# COUNCIL DECISION REQUEST

SUBJECT: Preliminary Plat of Residential Subdivision at 1601 E. Underwood Ln (S11-002)

SUBJECT: **12 Lot Single-Family Residential Subdivision** **S11-002**  
1601 E. Underwood Lane – Tuscany Estates

**PRELIMINARY PLAT**

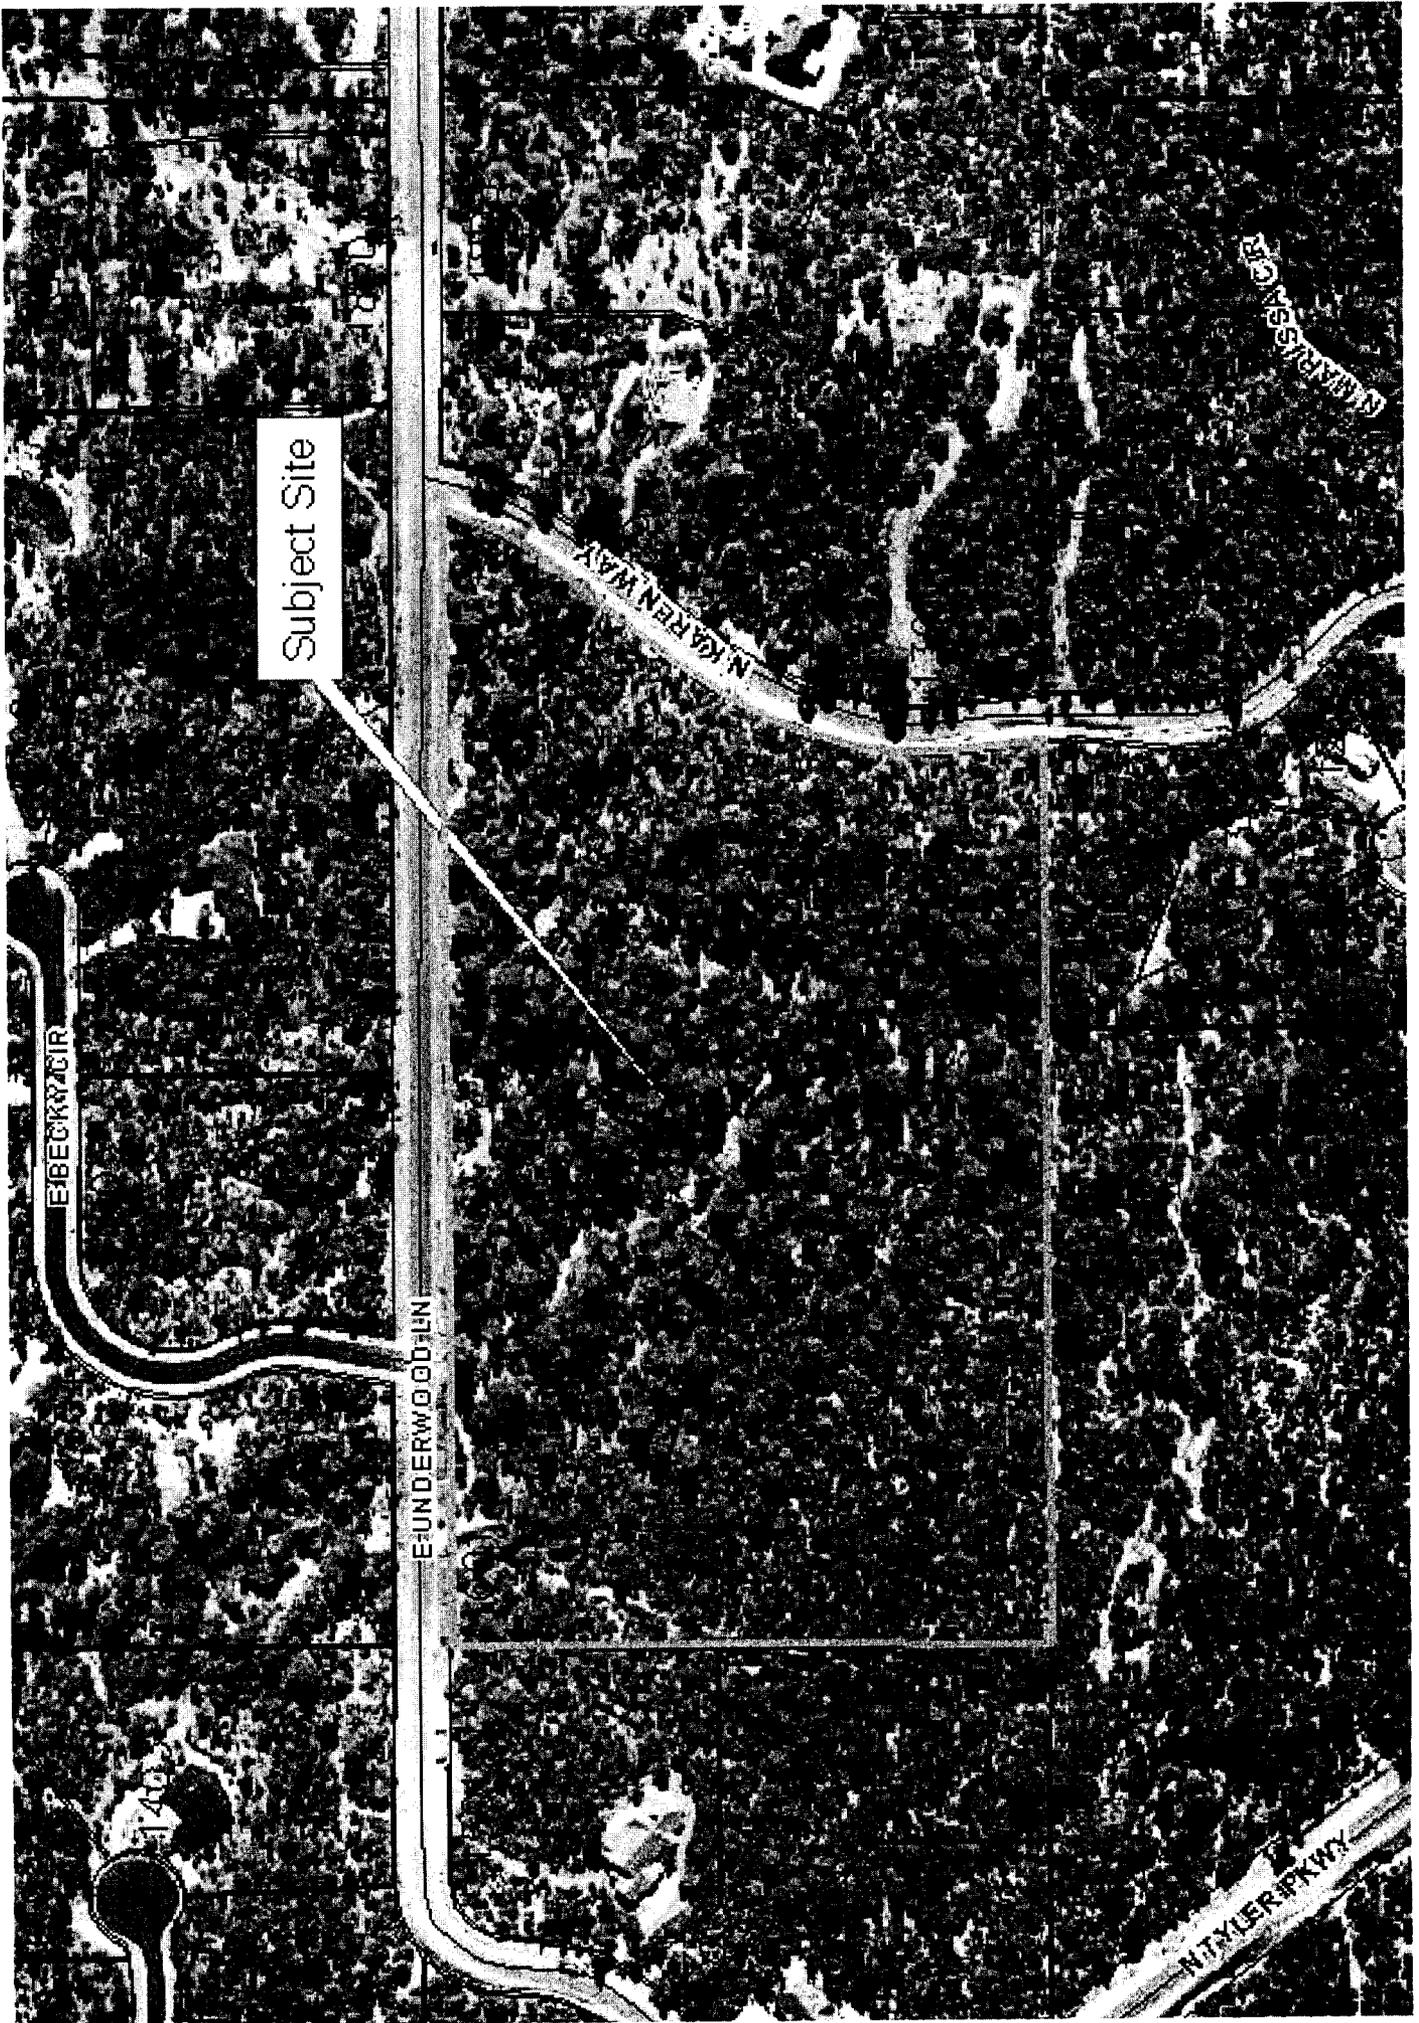
This application has been reviewed by affected Town of Payson departments and utility providers and no adverse comments have been received. Several minor corrections have been requested and are included in the conditions of approval. On the cover sheet of the Final plat these specific items need to be amended with the Final Plat submittal; The subtitle shall say, “A Resubdivision of Lot 20B of Payson Three...”, and note No. 14 needs to be corrected to read, “Section 15-07-002H of the Unified Development Code.”

Lots 1, 11, and 12 as shown on the preliminary plat are "Hillside" lots and will require individual engineered grading and drainage plans. Careful placement of building envelopes on some of the remaining lots has exempted them from hillside provisions, therefore a note shall be required on the Final Plat equivalent to the following: "Any adjustment to a building envelope will require a study to determine if the adjusted envelope makes the lot a "Hillside" lot needing to meet all the requirements of Section 15-07-002H of the Unified Development Code." Also, the final plat shall include a tie, including bearing and distance, to an acceptable government corner with full description of the corner.

1. The final plat shall be in substantial conformance with the preliminary plat submitted, sheet one sealed 8/24/11 and sheet two sealed 8/30/11 and shall not exceed a total of 12 lots.

2. A final plat shall be submitted within 12 months of Council approval of this preliminary plat.
3. A note shall be included on the Final Plat equivalent to the following: "Any adjustment to a building envelope will require a study to determine if the adjusted envelope makes the lot a "Hillside" lot needing to meet all the requirements of Section 15-07-002H of the Unified Development Code."

4. The Final Plat shall include a minimum lowest finish floor elevation for all lots containing a drainage easement.
5. On the Final Plat Note No. 14 shall be corrected to read, "Section 15-07-002H" of the Unified Development Code.

6. On the Final Plat the subtitle needs to say "A Resubdivision of Lot 20B of Payson Three...."
7. The final plat shall include a tie, including bearing and distance, to an acceptable government corner with full description of the corner.

8. A note shall be added to the final plat stating, "Driveway widths outside the building envelope, on all lots, shall be limited to a maximum of 14 feet wide unless a greater width is needed to meet Fire Department requirements."
